SERVICE MANUAL

Addo-X SERIE 40

40 SERIES

Fig. 4

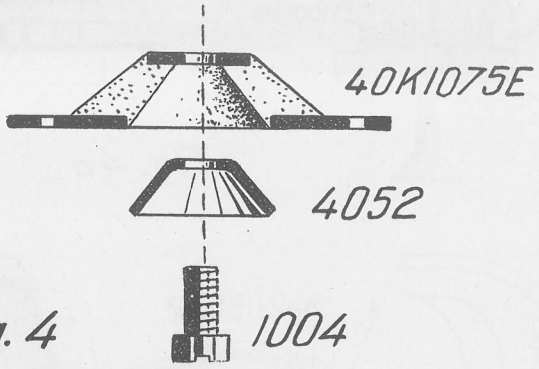
2. In order to avoid exaggerated vibrations on the dampers [40K1075E], a new part is used, namely Damper Cone 4052. This part is placed as per Fig. 4.

Fig. 4b

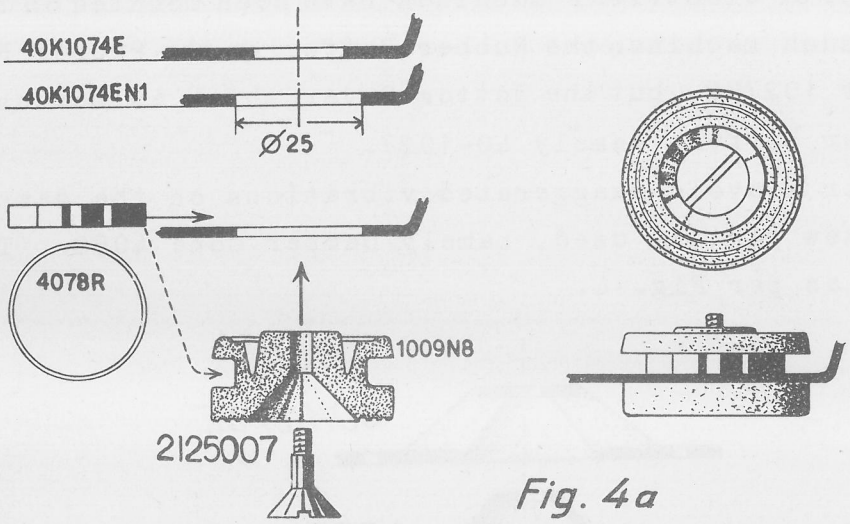
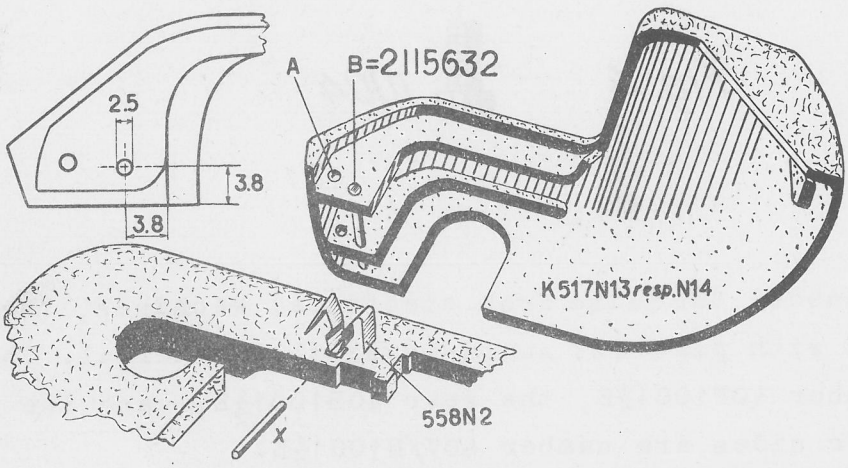
A new Spring 558N2 for attaching the ribbon spool covers K517N13, -N14 has been designed. This spring can also replace Spring 558 on old machines. It is fixed in the square hole of the cover by means of Taper Pin X, Fig. 4b. [X is for Hand Machines 2112002, and for El. Machines 2112003].

When using the Spring 558N2 for replacing the 558 it will be necessary to bore the holes B as per Fig. 4 b and fasten the Pin 559 in the ribbon spool covers.

Fig. 5a

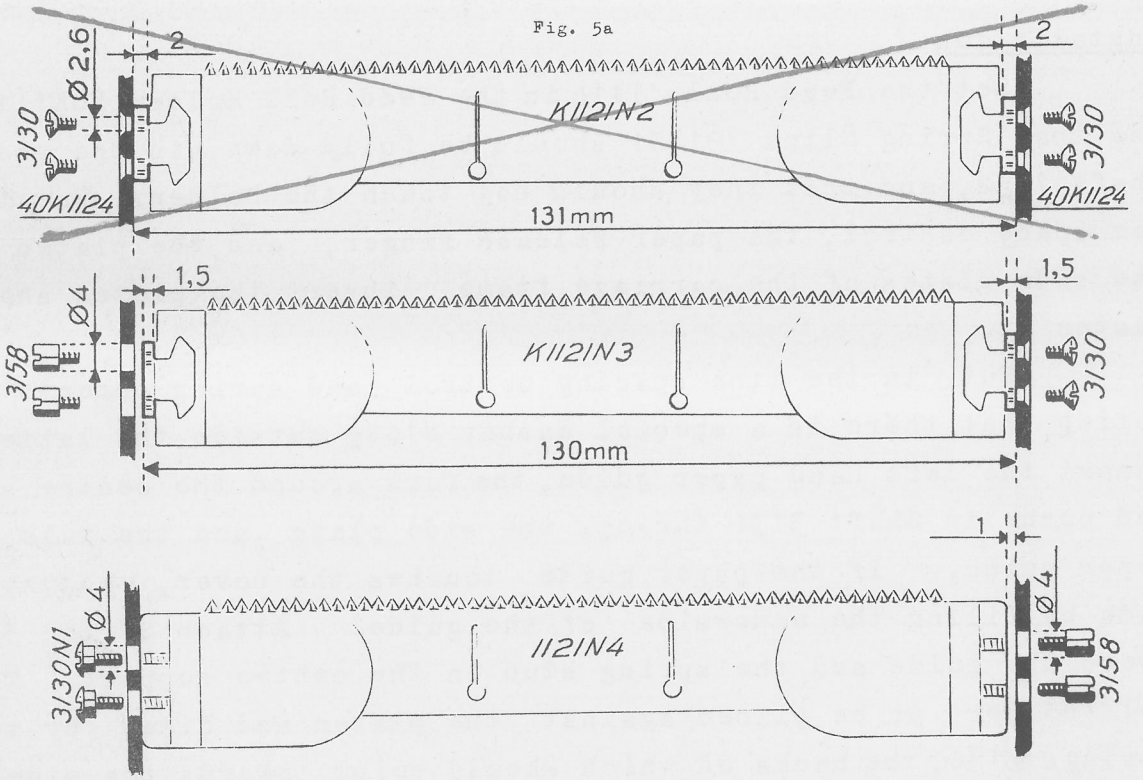
The fixing brackets of Paper Knife K1124 have been modified so that the knife can now expand and contract in different temperatures. The modification will be evident from Fig. 5a (April 1952).

Paper Knife 1121N4 was introduced in December 1952. It is fixed in the left carriage end and moves freely on the right side in order to keep a determined distance to the platen ratchet wheel. N4 can replace both N3 and N2 if the fixing holes of the carriage frame are made ø 4.

Fig. 5b

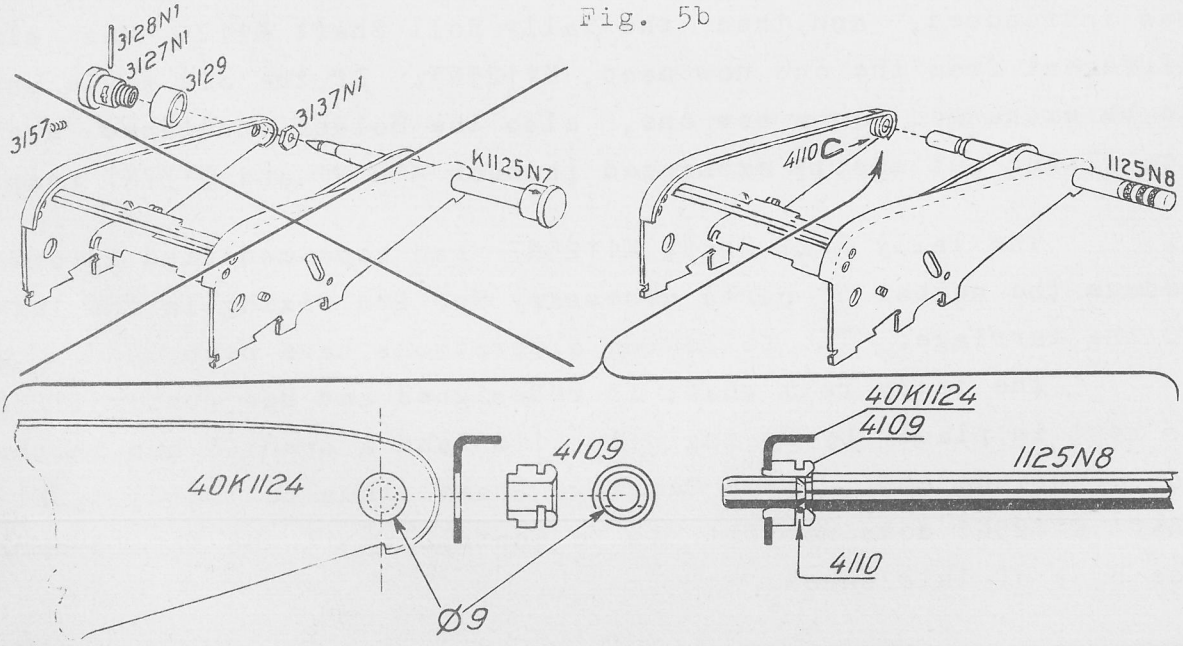
Tally Roll Shaft 1125N8 can be used on older carriages if Hub 4109 is riveted to the left hand carriage end. Put the shaft in place before attaching Spring Clip 4110.

Fig. 5c

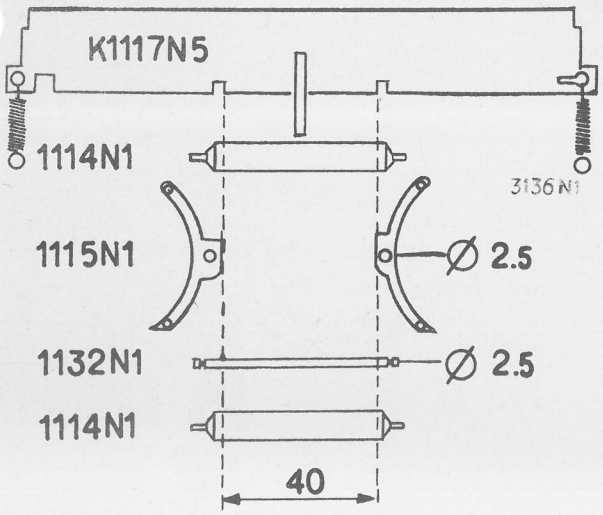
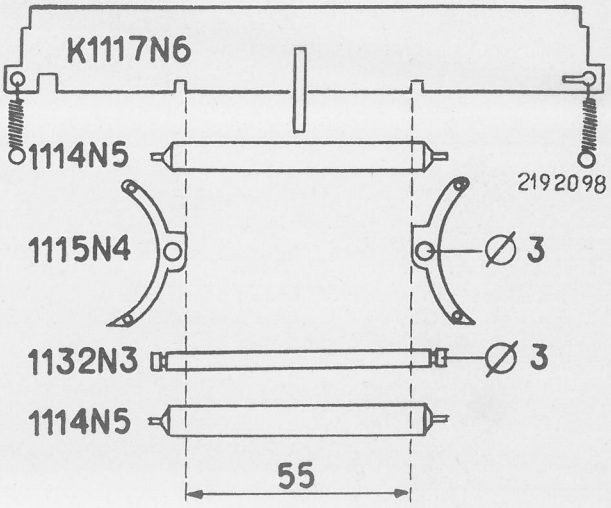
The figure to the left is showing the paper feed rollers hitherto used, the right hand figure showing the new rollers and holders which can also be installed in older machines.

Part K1117N5 can be used together with the new rollers, if slots for the holders are made as per the right hand figure. In all cases, however, the notch of the carriage frame must be widened so as to allow free movement for the wider rear roller.

The wider Rollers 1114N5 require a stronger spring to be used instead of the formerly used 3136. The stronger spring has the number 2192098 and as it can also be used on old machines Spring 3136 is no longer furnished.

Fig.13

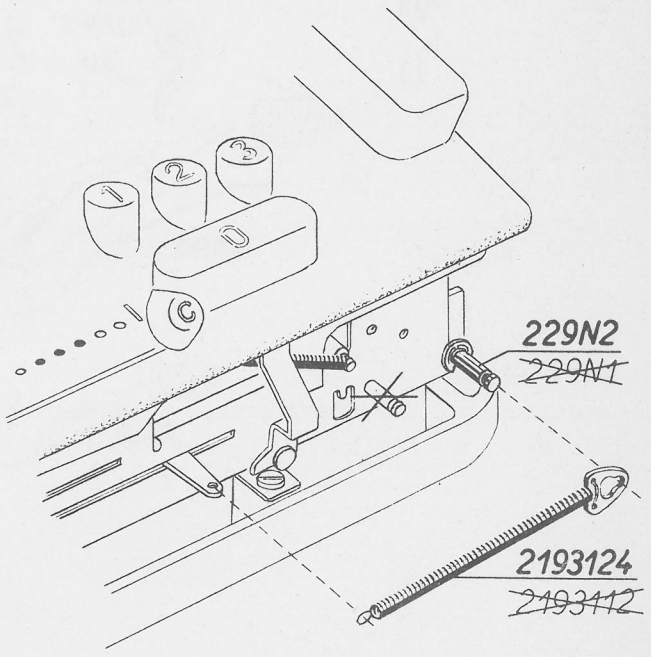
In order that the step lever should have as uniform a spring load as possible we made a new and longer key board front spring. This new spring, which is number 2193124, is anchored on Shaft 229N2 as shown in fig. 13.

When replacing the formerly used spring 2193112 by the new one 2193124, also Shaft 229N1 must be replaced by 229N2, and the spring stud removed.

Machines coming from the assembly line after July, 1955 are equipped with Spring 2193124.

Fig. 30

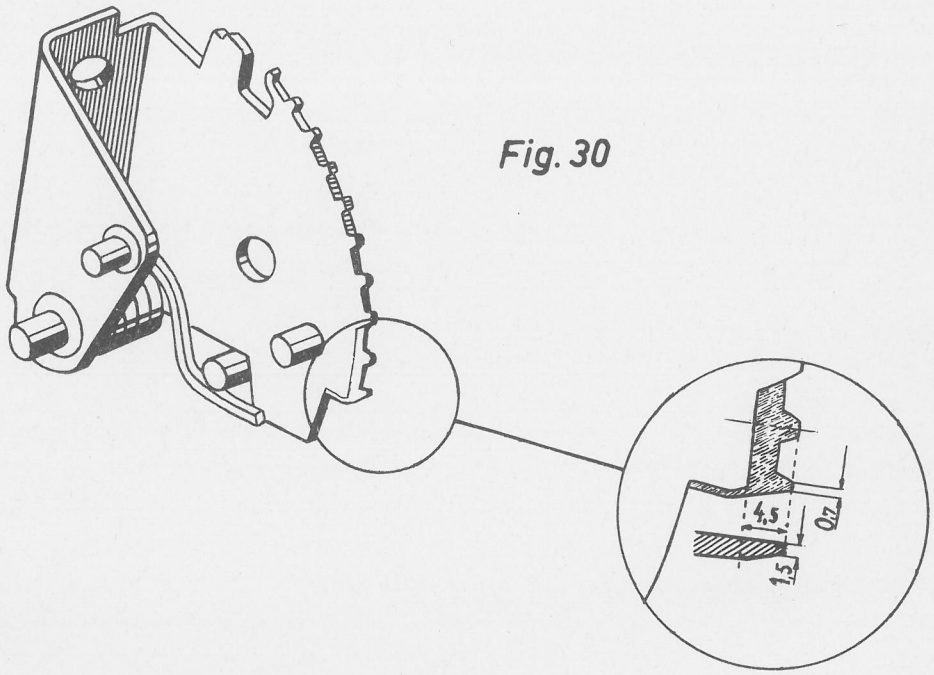
If the Handle has to be forced in bottom before it returns,

you are advised to modify the last tooth of the Full Stroke Ratchet K122 as follows:

1. Shorten the tooth so that the top becomes .7 mm only.
2. Shamfer two teeth to a thickness of 1.5 mm. See Fig. 30

Fig. 36

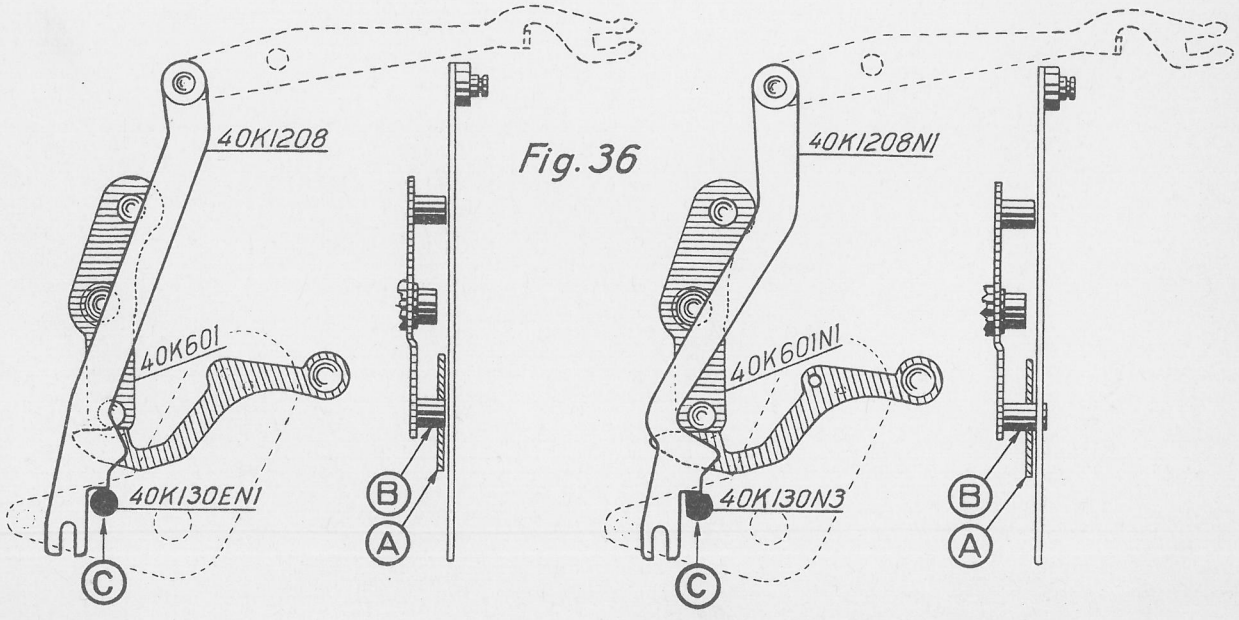
3. The stud "B" of the Centre Shaft 40K601 has been lengthened in order to provide better engagement with the latch "A". At the same time the latch was modified as per Fig. 36.

To give free movement for the lengthened stud, Starting Bar 40K1208 had to be redesigned as shown below.

In connection with the above modification also stud "C" of the Main Shaft was altered to ensure that the starting bar cannot slip down and start the motor when the motor key and a numerical key are depressed at the same time.

Of the parts mentioned only the Totalizer Coupling 40K806E with the new latch can be used on old machines. The other parts have got N-numbers as they cannot be used on machines manufactured before the modification was put into production.

Centre Shaft 40K601N1	In production from:
Starting Bar 40K1208N1	40E-A36995,
Main Shaft 40K130EN3,	41E-A87215,
	341E-A87150,
	341EC-B35009.

Fig. 37

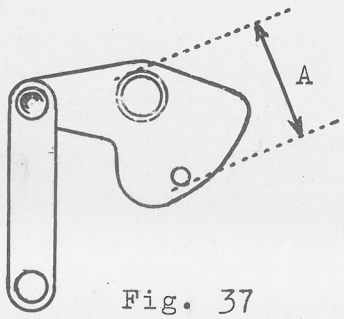
4. To provide better engagement the Start Lever 40K4204 has been slightly modified as regards the studs. The modified part has number 40K4204N1, and it cannot be used on machines prior to: 341EC - A85084, 341E - A86717, 41E - A86272 and 40E - A86900.

On 40K4204 the distance A is 14.5 mm; on 40K4204N1, 13 mm.

Fig. 62/1

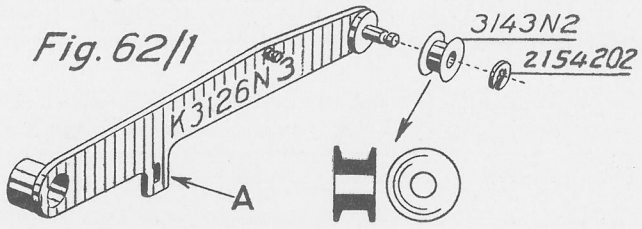
The first machines of the 40-series were equipped with Print Hammer Frames that have riveted distance pins instead of pressed lugs. When installing K3126N3 and K3126N4 in such machines it will be necessary to file the extension "A" for free movement.

Fig.88

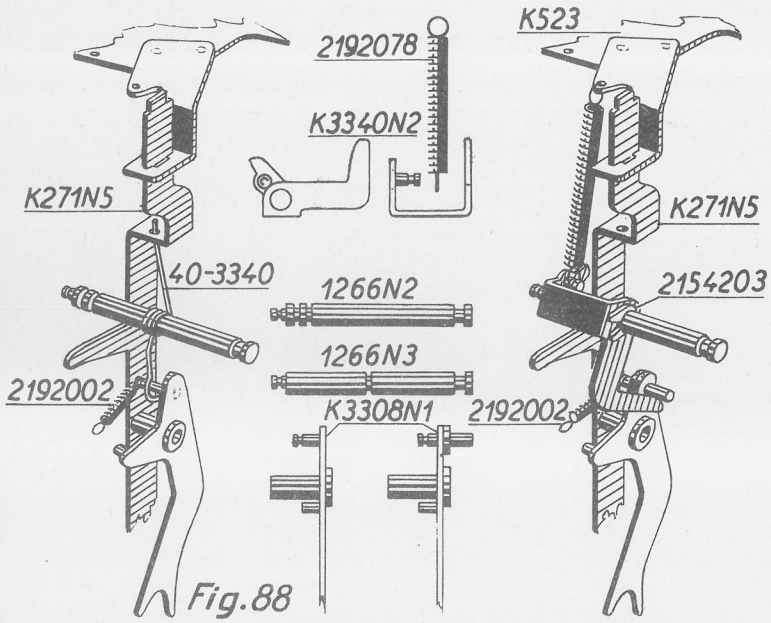
Twist Spring 40-3340 required too much adjustments, and has been superseded by the construction shown in Fig. 88. It consists of a Lifting Arm Retainer 40K3340, kept in position on a new Shaft 40-1266 by Spring Clip 1013, and a Spring 300-9300. The parts can be used on older machines if Lifting Arm 40K3308 is exchanged for a new one with a double pin.

Fig. 91/1

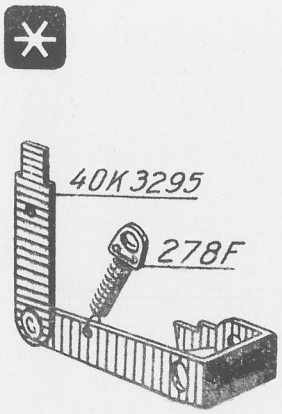
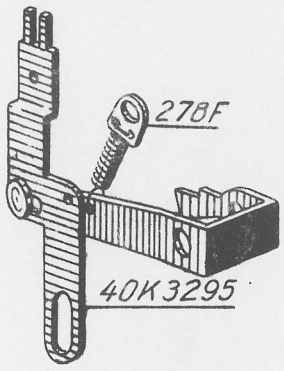
Fig. 91/1 shows the first type of total and sub total keys that was used on the 40 series. However, in order to improve the guiding of the keys they were modified to the shape shown in Fig. 91/2. New style keys can replace the old ones if Spring 931 is exchanged for 8640 at the same time.

Fig. 92

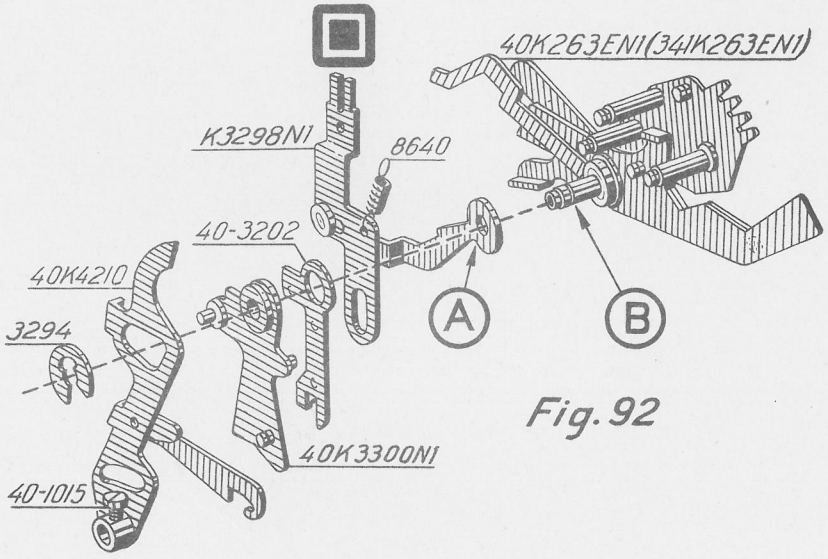
Machines with numbers above those mentioned thus have a Spring Clip 3294 [Fig. 92] in the groove "B", limiting the lateral play of the parts. What caused this modification was the fact that the Start Balance Blocker 40-3302 could come at the side of the stop lug of the Start Balance 40K4210 thus failing to stop it. See Fig. 33.

Fig. 113

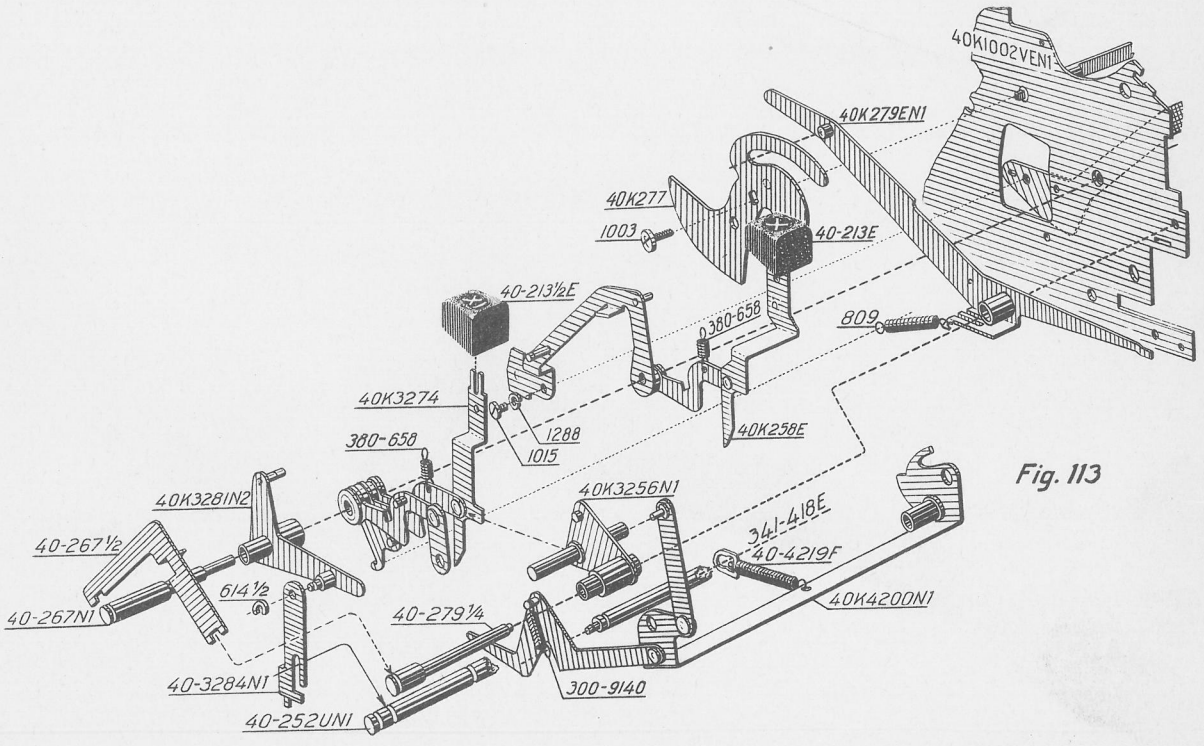
A new shaft, 40-279¼N1, is introduced. On this is pivoted Starting Bridge Actuator 40K3256N1, modified into the shape shown in Fig. 113, and Total Locking Lever 40K279EN1, which is provided with a bearing tube instead of the double bent bracket.

Shafts 40-267N1 and 40-279¼N1 [number wrong on Fig. 113] are locked laterally by Locking Knee 40-267½. On this part there is a lug which should prevent the repeat stem from jumping up and getting blocked on the key board. However, on some machines there is locking knee without this lug. Such parts should be exchanged for new ones.

Fig.13M-200

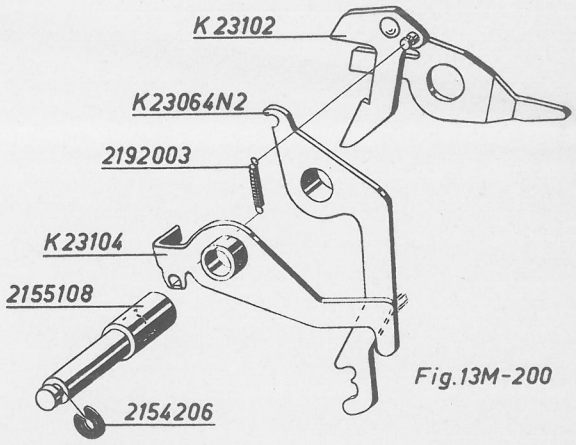
Cause of the trouble: This kind of trouble may be caused by a bind in Part K23104. If there is a bind, namely, Part K23104 may remain in set position, i.e. the position it has during a Sub-Total stroke. This position is shown in the right hand figure below. Note that Part K23102 will not actuate the latch when rotating into active position for Total.

The left hand fig. shows correct initial position of both parts. When K23102 rotates into Total position it takes K23104 with it, which it should.

A bind like this may appear in machines manufactured before October 1956, because in such machines there is nothing the hold the shaft, on which the two parts in question are fulcrumed, in position sideways. Consequently, the shaft can move sideways and jam the parts against the side frame.

Repair: In machines manufactured after September 1956 the parts K23064N2, K23104 and K23102 are fulcrumed on a Bushing 2155108 which guarantees free movement. The shaft then can jam the bushing, but never the parts on the bushing. The repair will be to install the modifed parts and the bushing. (The bushing has an outer diameter of 6 mm, and the only modification made to the K23104 and K23064N2 is an enlarging of the bearing holes).
